Program Bulletin

CUSTOMER SATISFACTION PROGRAM

SUBJECT: Air Conditioning System Inoperative or Cools Intermittently

MODELS: 2013-2014 Chevrolet Spark

3828227

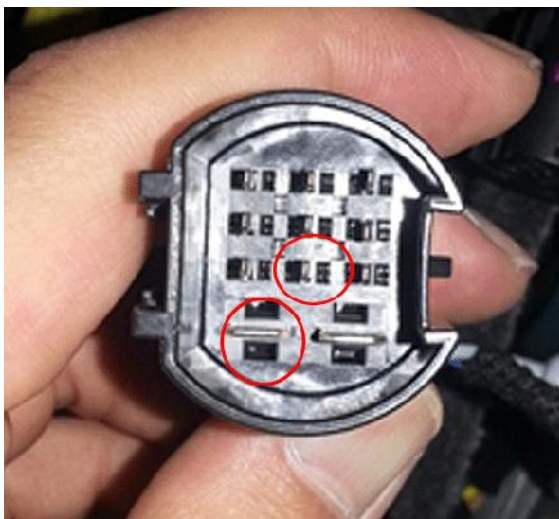
The switch installation procedure has been revised. A Caution statement has been added before Step 2, a revised illustration for Step 18 has been added, and Steps 26 & 27 have been revised. Please discard all copies of bulletin 13434A.

18. Connect the connector to the Low Pressure Switch and attach the new harness with C-clips to the A/C pipe.
